Centredale Manor Superfund Site
11/28/07 MAC Meeting
Continuing Dam Removal Discussion
10 am
Council Chambers, North Providence Town Hall

Centredale Manor Restoration Project Superfund Site

Hydrodynamic Analysis of Remedial Alternatives

Remedial Alternative Design Considerations: Alternative 4

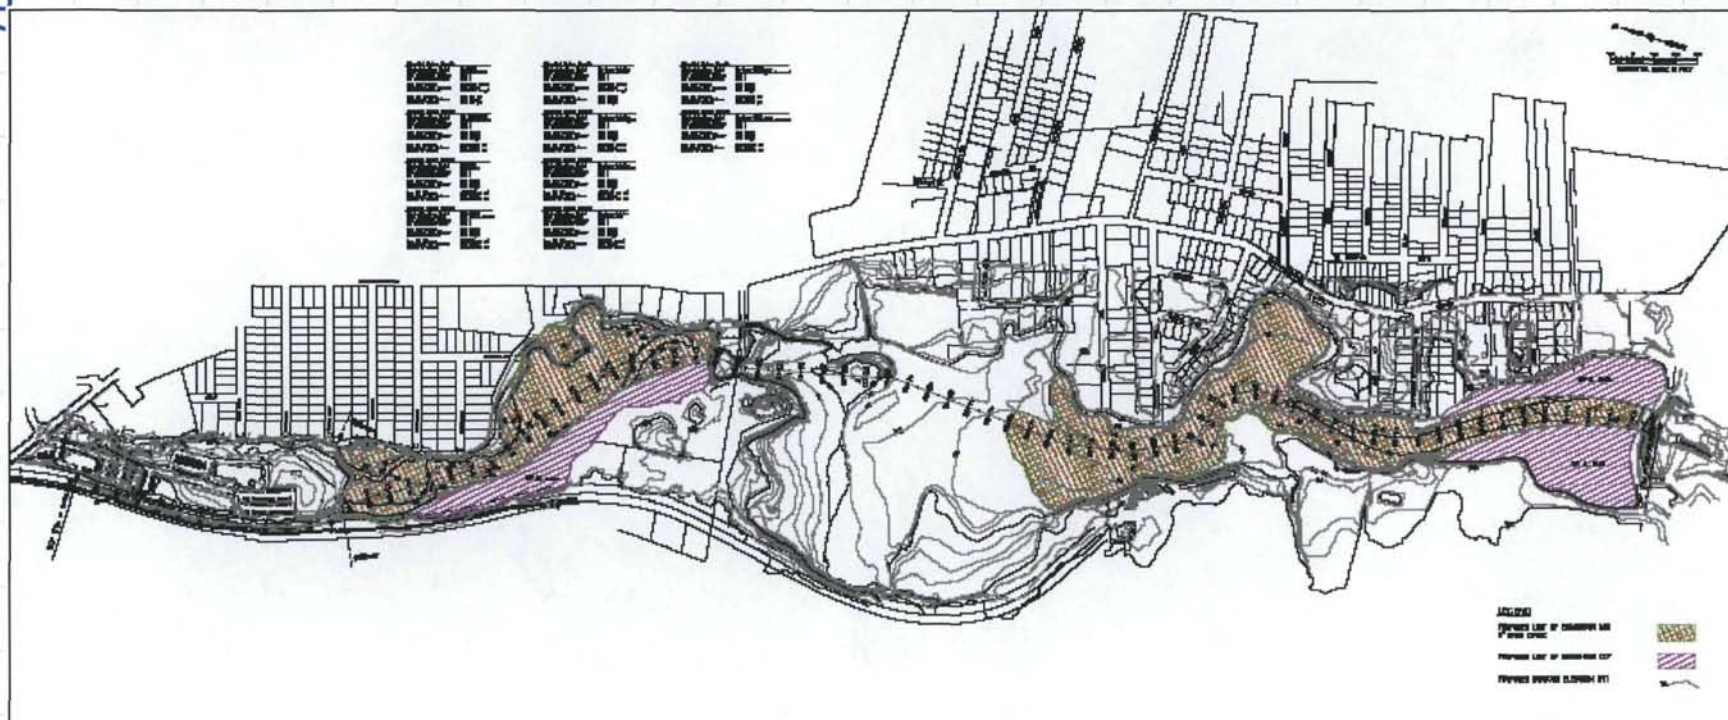
- Alternative 2 & 4 CDF acreage vs. pond acreage
- Artist rendition would be helpful
- Any fill of wetlands would require mitigation
- Need to investigate wetland requirements
